Sundry Print Report

Well Name: CORRAL 23-26 FED COM

Well Number: 204H

Type of Action: APD Change

C-102
Revised July 9, 2024
Submit Electronically via OCD Permi t ng

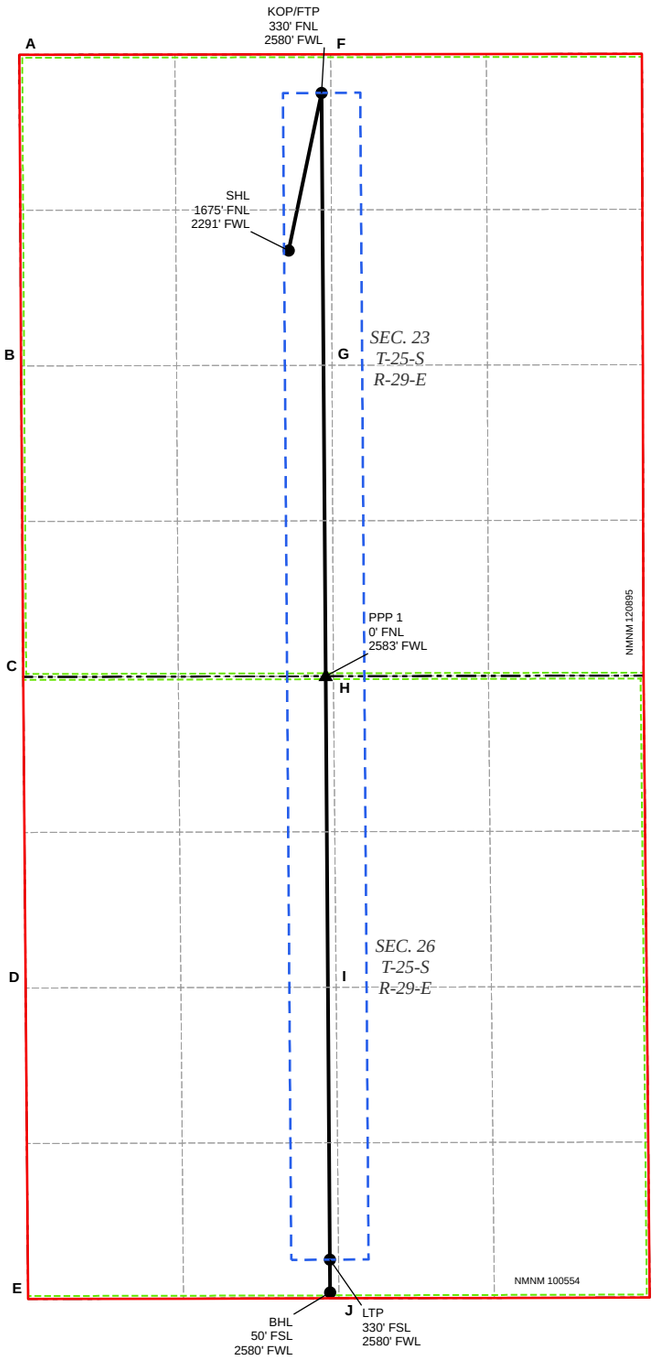
XTO Energy Inc. respectfully requests approval to make the following changes to the approved APD. Changes include KOP, FTP, LTP, BHL, Proposed total depth, and dedicated acreage, Formation TVD, Casing Design, Cementing Program, Mud Program.
APD ID 10400098959; Well API: 30-015-56712.

KOP: 1675' FNL & 2291' FWL OF SECTION 23-T25S-R29E 330' FNL & 2580' FWL OF SECTION 23-T25S-R29E
FTP: 330' FNL & 2340' FWL OF SECTION 23-T25S-R29E 330' FNL & 2580' FWL OF SECTION 23-T25S-R29E
LTP: 330' FSL & 2340' FWL OF SECTION 35-T25S-R29E 330' FSL & 2580' FWL OF SECTION 26-T25S-R29E
BHL: 50' FSL & 2340' FWL OF SECTION 35-T25S-R29E 50' FSL & 2580' FWL OF SECTION 26-T25S-R29E

The proposed total depth is changing from 27573 MD; 11249 TVD to 20752 MD; 10591 TVD

The Dedicated acreage is changing from 1920.00 to 1280.00.
